NAIROBI EXPRESSWAY AUDIT

INSTITUTE FOR TRANSPORTATION AND DEVELOPMENT POLICY
JAN 2023

To identify opportunities to improve walking and cycling facilities along the A8 corridor, the Institute for Transportation and Development Policy (ITDP) and United Nations Human Settlements Programme (UN-Habitat) conducted a comprehensive NMT audit in collaboration with officials from Nairobi City County (NCC), Nairobi Metropolitan Area Transport Authority (NaMATA), and KeNHA. Participants observed the impact of the Nairobi Expressway on public transport, pedestrian, and cyclist movement. This report gives an overview of the existing NMT facilities along the Expressway and provides feedback on how to improve the facilities.

Figure 5. Footpath presence and clear width: James Gichuru to University Way.

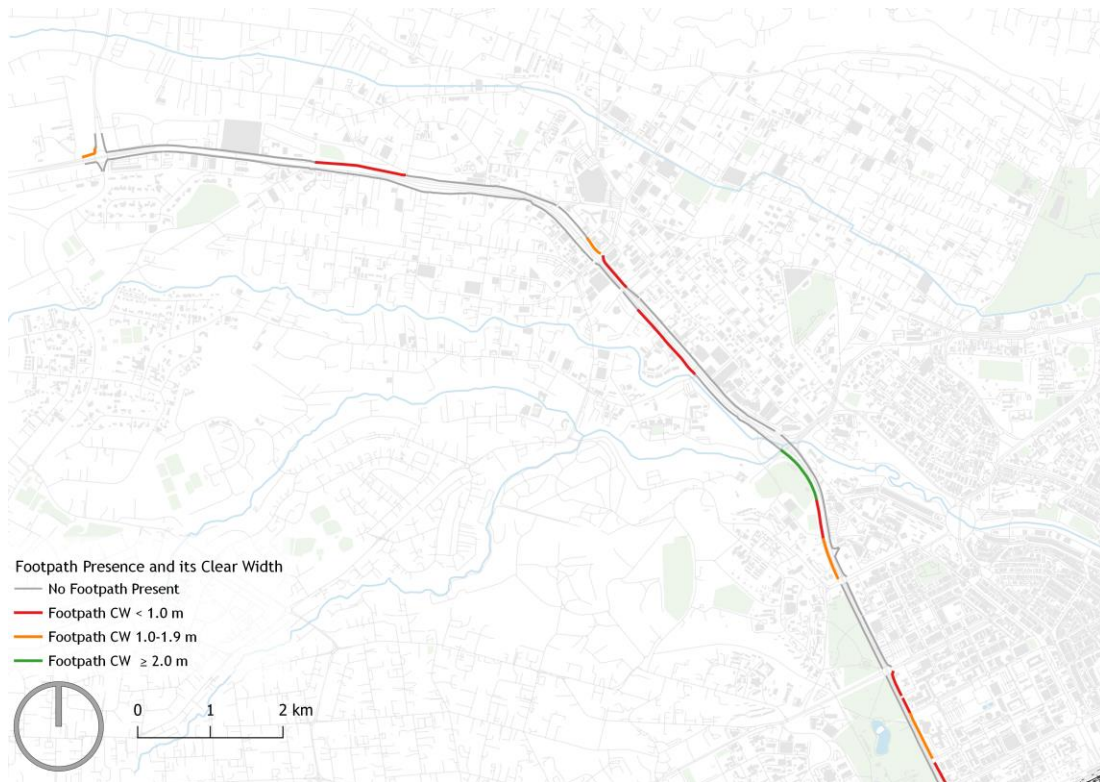
Few footpaths are available along the A8 corridor. On street segments with footpaths, very few have 2 m of clear width, the minimum needed in urban areas. Most of the footpaths on Uhuru Highway and Waiyaki Way before the expressway constructed were demolished to pave way for construction of the Expressway, and few of the walkways have been reinstated.

Where footpaths exist, the available clear width is inadequate, the footpaths often end abruptly, and there is no universal access.

Figure 9. Presence of shade: James Gichuru Roundabout to University Way

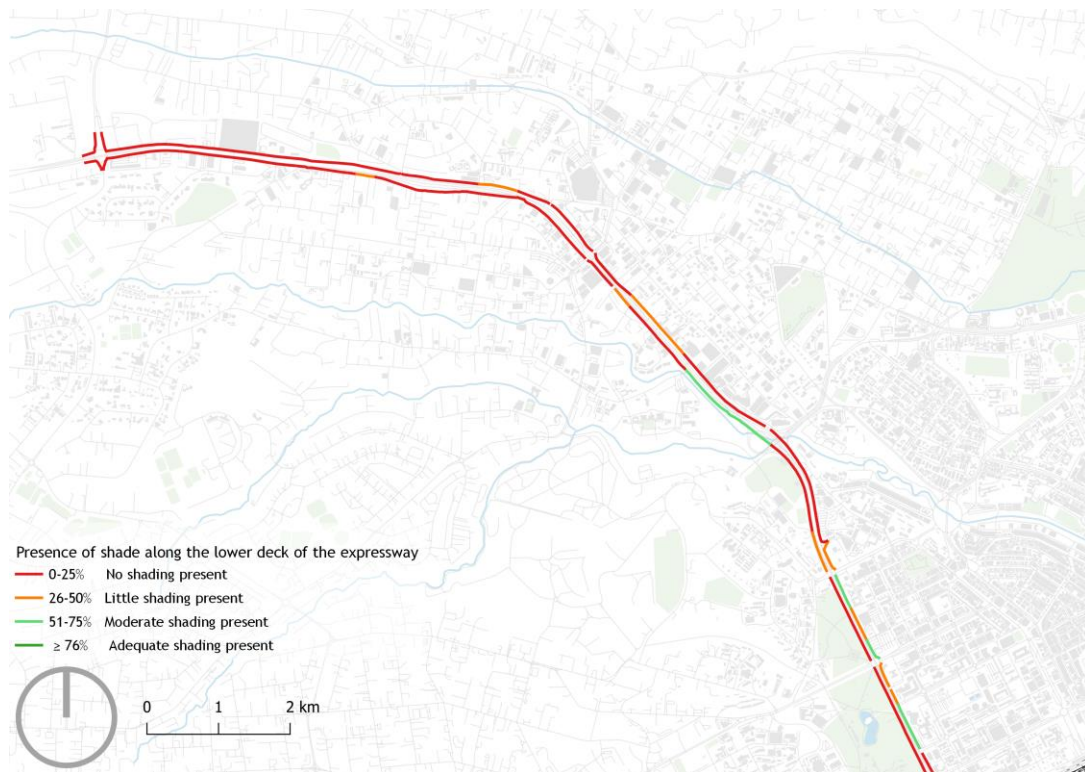
The construction of the Expressway resulted in the loss of at least 2,500 trees.¹ According to the National Environmental Management Agency (NEMA), the contractor was expected to plant 3,000 assorted seedlings along the 27 km stretch to compensate for the trees brought down during construction. The maps below show shade is very limited along the corridor.

Figure 14. Footpath obstructions: James Gichuru to University Way.

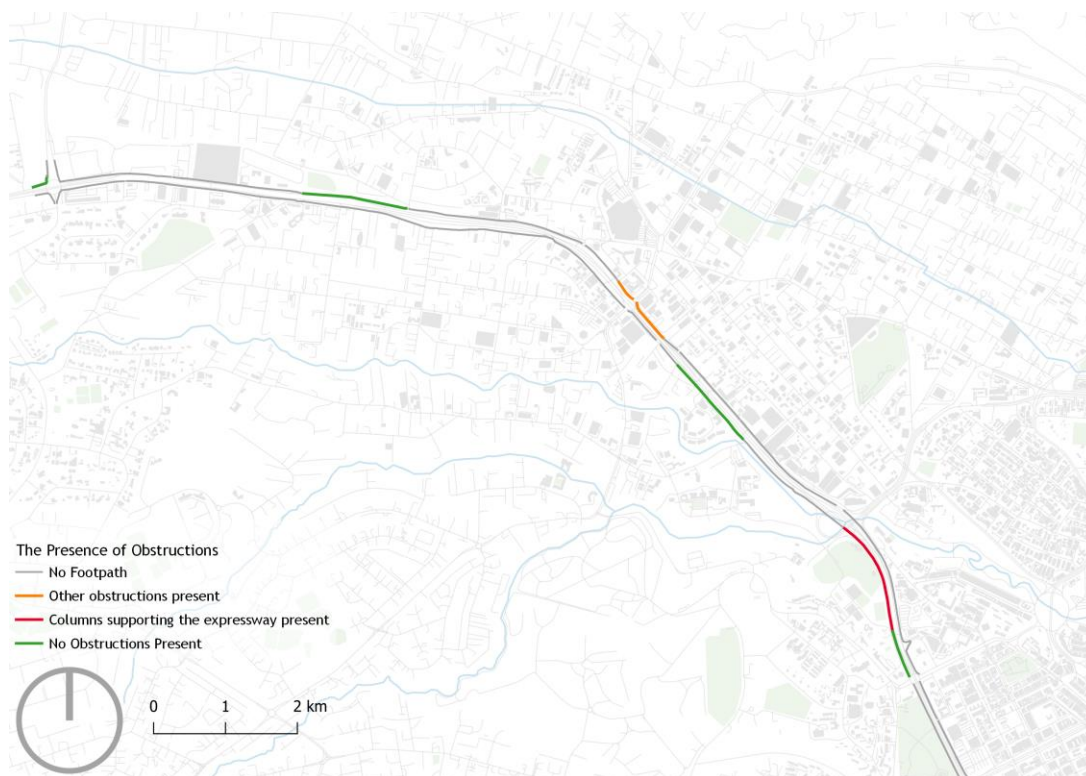
Footpath obstructions along the corridor include expressway columns, utility poles, and and construction debris. The maps below display the presence of obstructions.

Figure 19. Presence of universal access: James Gichuru to University Way.

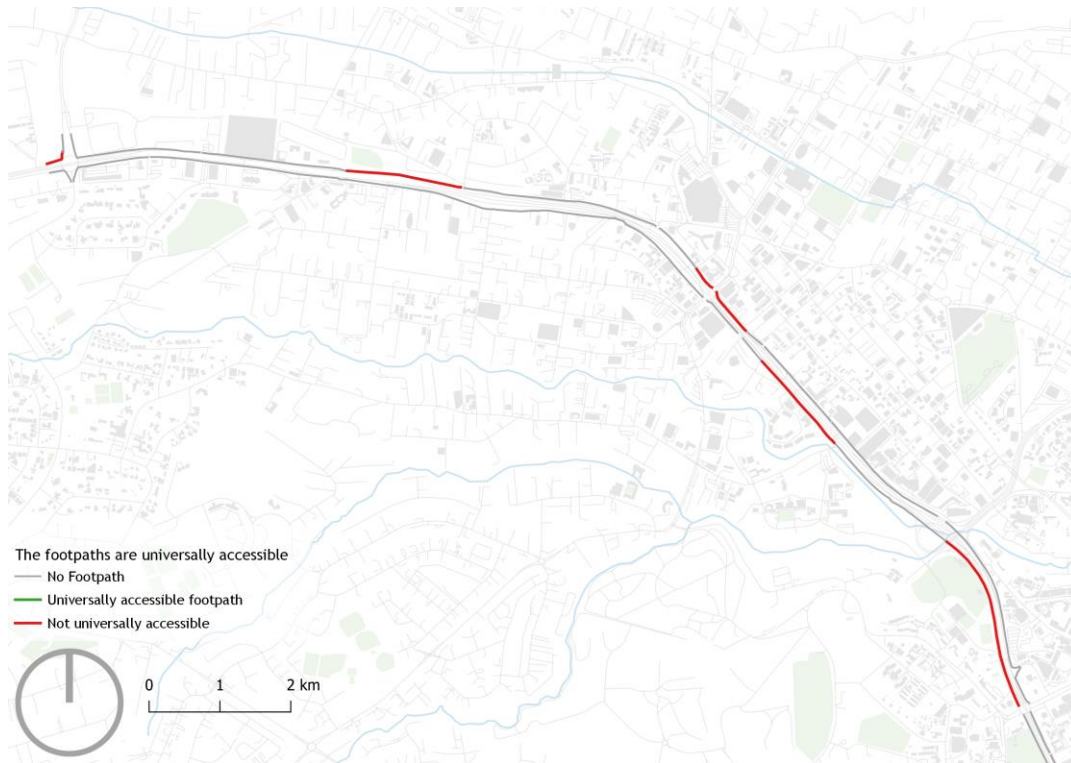
There are few sections with footpaths that are universally accessible. Disabled pedestrians are forced to use the carriageway, forcing them to use the carriageway next to fast-moving vehicles.

Figure 27. Crossing types: University Way to Nyayo Stadium.

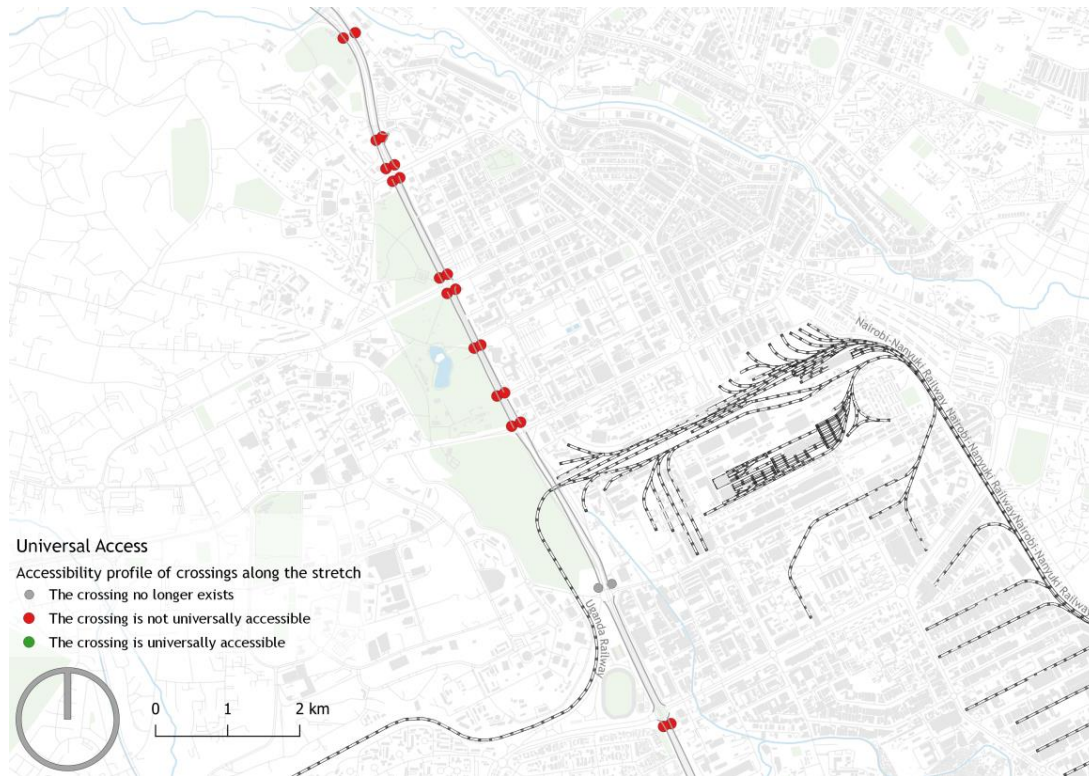
Construction of the Expressway has made it difficult for pedestrians and cyclists to cross the road, especially along sections where the expressway is not elevated. The only level crossings that exist after the expressway construction are on Uhuru Highway. One of the major crossing points on Uhuru Highway is at St. Paul's. The crossing is not marked and lacks universal access despite the high traffic of pedestrians, primarily students, crossing the road. Other important crossings at Airtel, Safaricom, and other locations no longer exist.

Two footbridges were demolished and reinstated: GM and Imara Daima. The tunnel at the University of Nairobi remained in place. The universally accessible footbridges are used by motorcycles, creating a nuisance for pedestrians and cyclists. The new footbridge at GM is not universally accessible and is very long, making it quite inconvenient for pedestrians to use.

Figure 36. Public transport facilities: University Way to Nyayo Stadium.

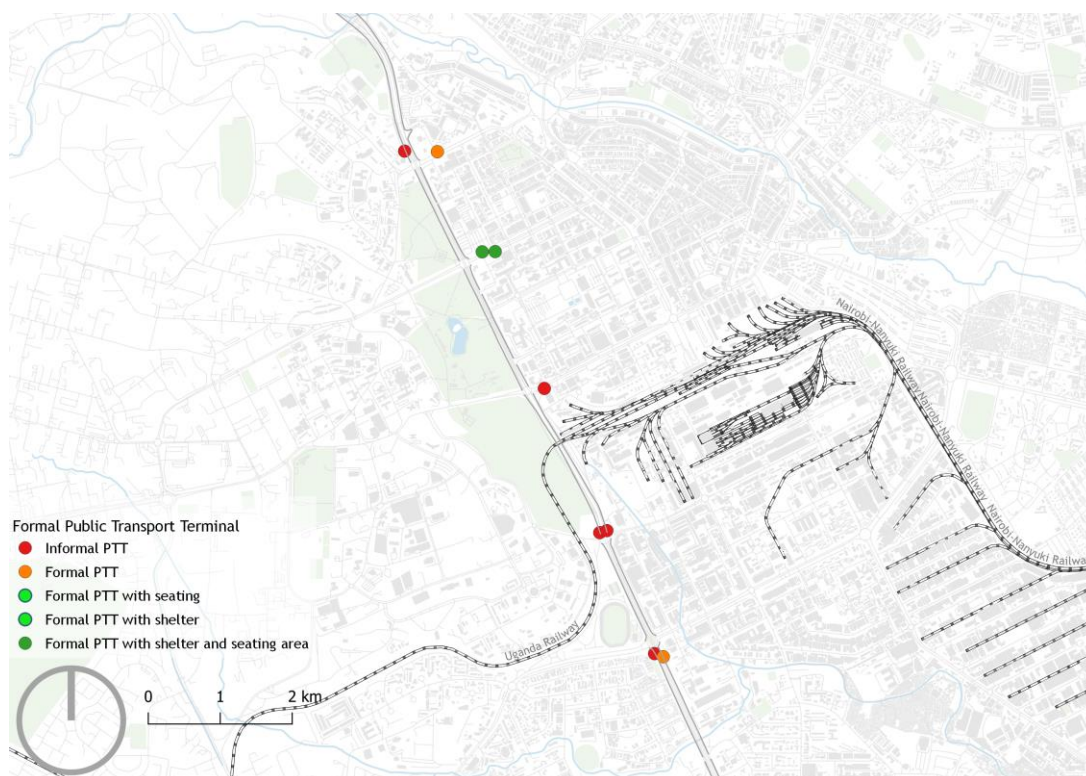
Public service vehicle (PSV) boarding, and alighting happens at informal stages along the corridor. There are few bus shelters with seating and other facilities that are important to improve convenience for public transport users.
